Flash Heads ELB 1200 – Tilt bracket defective		TECH-NOTE-023 Page 1/9	
Document.:	TECH-NOTE-023.docx		Rev.: 01		
Description:	Technical note for tilt head washer

Project:	ELB1200	Document No.:	10_00099		
Project No.:	10_00099	Revision :	01	Version :	1
		Elinchrom No. :	280.413

Fig.8: Step 6: Remove the older washers.

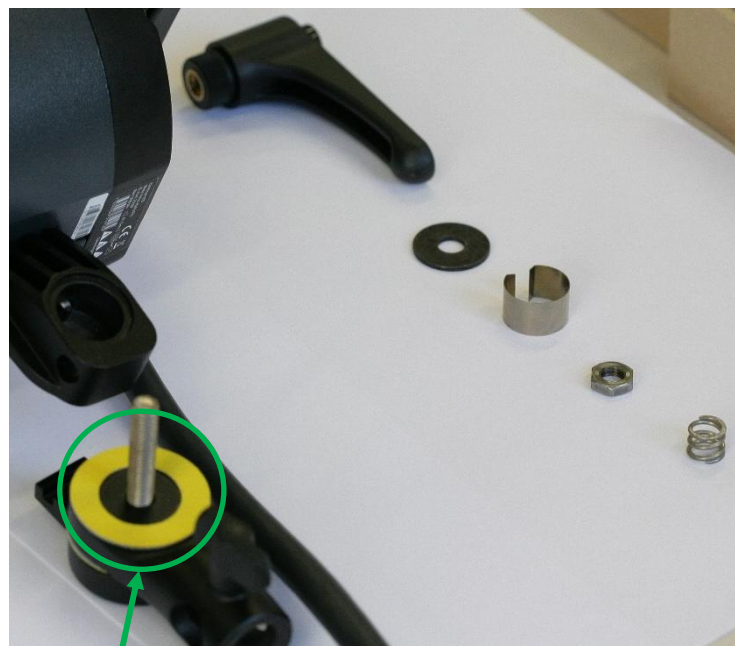
After field tests, photographers told us that, on some tilt brackets, the friction made by the washer of the tilt head was not enough to keep in position the head with big accessories (ex: very deep softbox). The material of this washer was the Habasit S-10/15.

Fig.9: Step 7: Replace by the new friction Bracket Washer 280.413 (2x).

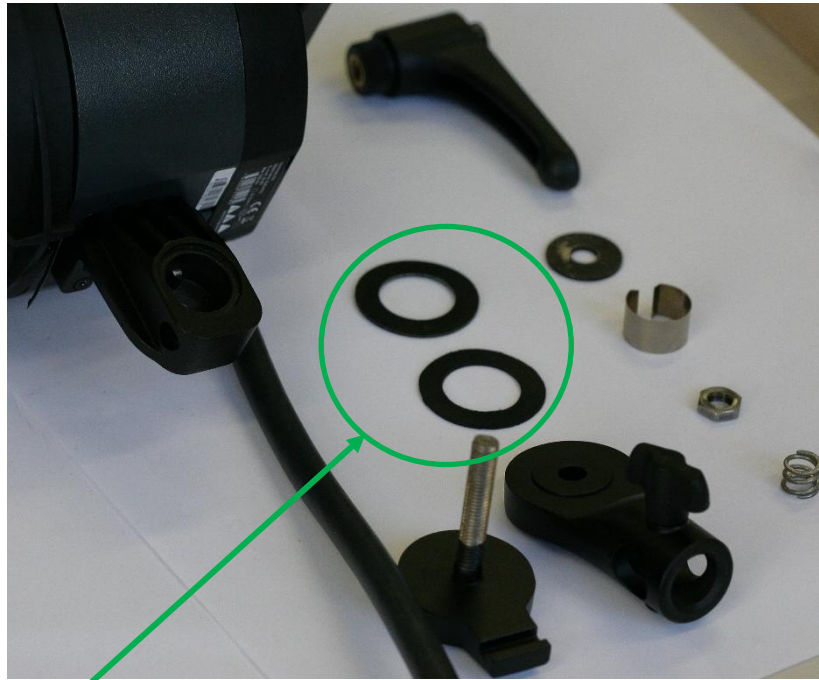
A new material has been selected for the washer (Habasit MAM-04 H). It looks similar to Habasit S-10/15 (composite build with rubber and fiber) but is totally black color. Two washers are necessary per tilt head.

You will find below the process to follow to replace the old washer (Habasit S-10/15) by the new (Habasit MAM-04 H).
